SUBMITTAL SUMMARY REPORT 33138

PLAN NAME:	WALMART NEIGHBORHOOD MARKET STORE #3009-1000	LOCATION:	16625 SE 91ST PHILLIPS CT THE VILLAGES,
APPLICATION DATE:	07/25/2025	PARCEL:	6722-200-003
DESCRIPTION:

SUBMITTAL DETAILS

Sheet No.
C1.2

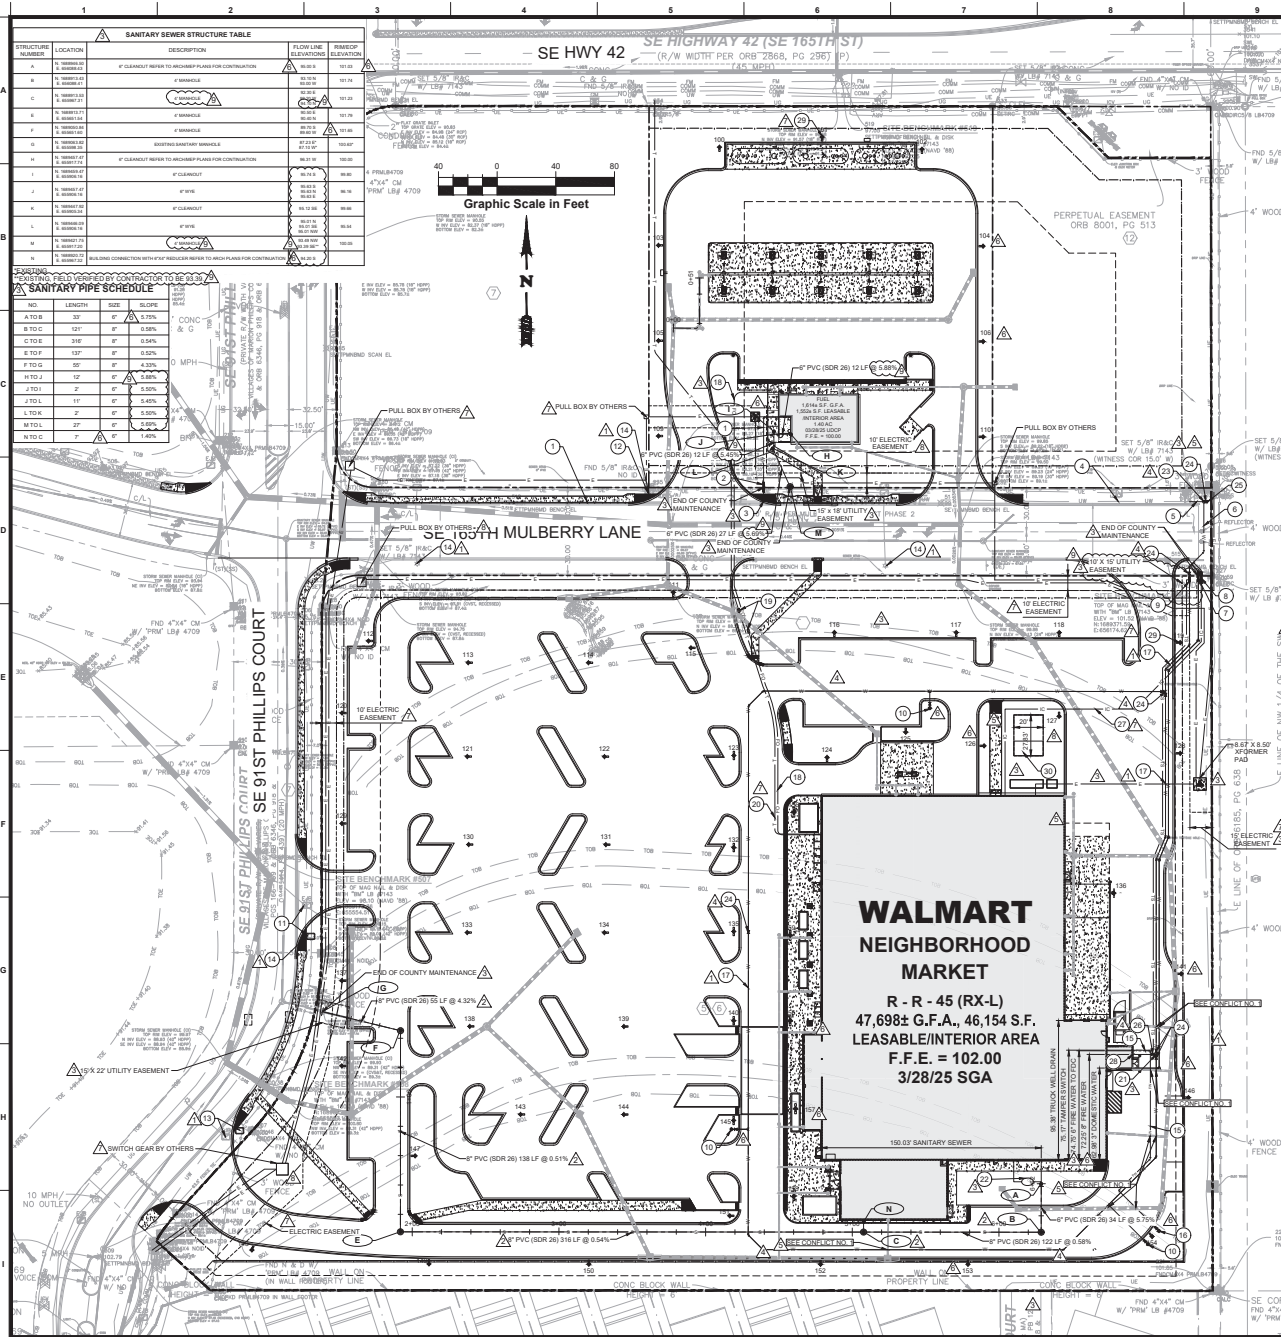
N/A 6.14.2.C.2(e) - Grease Trap, FOG Worksheet 10/29 - Changed to 1000 Gallons. S&S by EOR. Shown on plans and submittal letter. 8/12/25 - C1.3 Maximum grease interceptor size is 1250 per FAC. (2) Grease interceptors calculations will need to be displayed, and signed and sealed by the engineer of record.
N/A 6.14.2.C - Industrial Pretreatment 10/28 Per response letter - No. Service Station will be pre-packaged. 12/25 - C1.3 Is there pre-treatment required for the fuel station? Will they be doing any food preparation, cooking or have any three compartment sinks?
N/A 6.14.3 - Onsite Waste Treatment and Disposal System (OSTDS) - connection requirement on plan
YES 6.14.3.B - Springs Protection Zone 10/28 - Acknowledged. Secondary Springs Protection Zone
YES 6.14.4 - Water (potable) Capital Charges and Flow Rates - proposed use identified to calculate 10/28 - Acknowledged. Capital charges and flow rates will be calculated during the permitting stage, before approval.

YES 6.14.4 - Water (irrigation) Capital Charges and Flow Rates - total irrigated area identified 91,613 SQFT - Shon of C1.3, lower right. Capital charges and flow rates will be calculated during the permitting stage, before approval.
YES 6.14.4 - Sewer Capital Charges and Flow Rates - proposed use identified to calculate 10/28 - Acknowledged. Capital charges and flow rates will be calculated during the permitting stage, before approval.
YES 6.14.5.A(1) - Submittal Requirements - Existing on-site & off-site mains and service connections All shown on plans.
YES 6.14.5.A(2) - Submittal Requirements - Proposed on-site & off-site mains and service connections All shown on plans.
N/A 6.14.5.A(3) - Submittal Requirements - Lift Stations layout, elevations, schedules No private lift station.
YES 6.14.5.A(6) - Submittal Requirements - Manhole locations, rim and invert elevations outside paved areas All shown on plans with measurements.

N/A 6.15.1 - Potable Water Distribution System
N/A 6.15.2 - Decentralized Water System (WTP)
YES 6.15.3 - Fire Protection/Fire Flow Capacity 10/28 acknowledged. Marion County Utilities to provide water. (2) Defer all questions and requirements to Marion County Fire Rescue. (3) C1.3 All Private fire hydrants need to be painted yellow.
N/A 6.15.4 - Water Main Piping Installation
NO 6.15.5 - Water Service and Connection 10/28 Partial Compliance. Need to show tee with gate valve and plug. 8/12/25 - C1.3 - 3 - Move water tap out of asphalt for fuel station. (2) - 5 - Need a T and a valve after the water main connection for Walmart Neighborhood storage.
YES 6.15.6.A - Potable Water Metering - individual/banked, size Shown on plans.
YES 6.15.6.B - Irrigation Water Metering - size 10/28 - 91,613 SQFT. Bubbled on C1.3 on lower right corner, and shown on Irrigation plan sheet. -8/12/25 - C1.3 Total irrigated square foot is needs to be shown on plans.

YES 6.16.4 - Wastewater Collection Systems (Gravity/Pressurized) Design 10/28 - Manhole G is now shown at the end of county maintenance. 8/12/25 C1.3 - If not already documented, a 15' easement needs to be provided from the property line to manhole F to cover sewer main. Manhole F will be the end of county maintenance and needs to be noted on plans.

YES Additional Utilities comments 10/28 revised 8/12/25 - C1.3 - Oval legend needs to be added to plan page. Only circles are displayed currently. (2) What page is the oval legend on currently?

YES Additional Utilities comments 10/28 revised 8/12/25 - C1.3 Add "End of County Maintenance" at meters and sanitary sewer clean out / manhole at property line. Should be a plan note and not only shown in the legend.
